**Liberty Hills Park • Irrigation Renovations**  
City of Thornton Project No. 16-359B

**Irrigation Plan**

Mainline Reconfiguration - Plan Detail

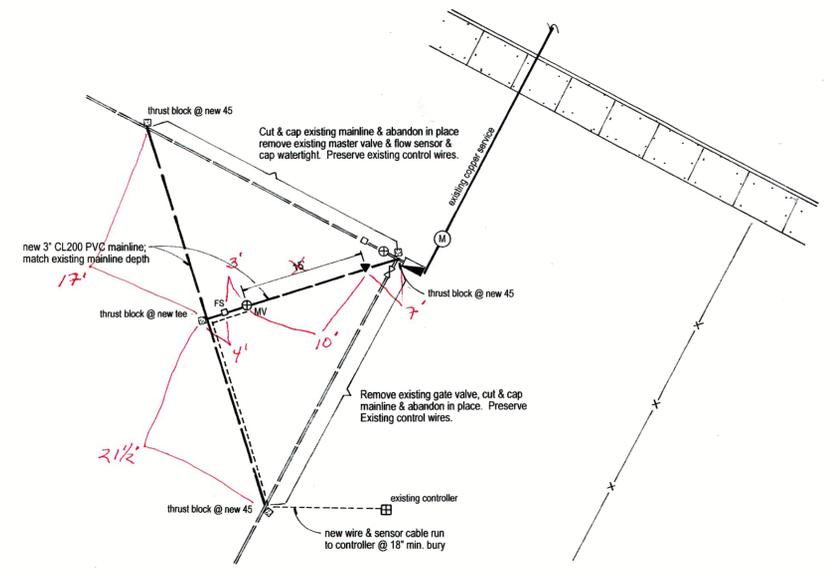
*\* used a 2" Bernad #210 cast iron gate rather than the specified Toro P220. 2 spare green wires installed in master valve box.*
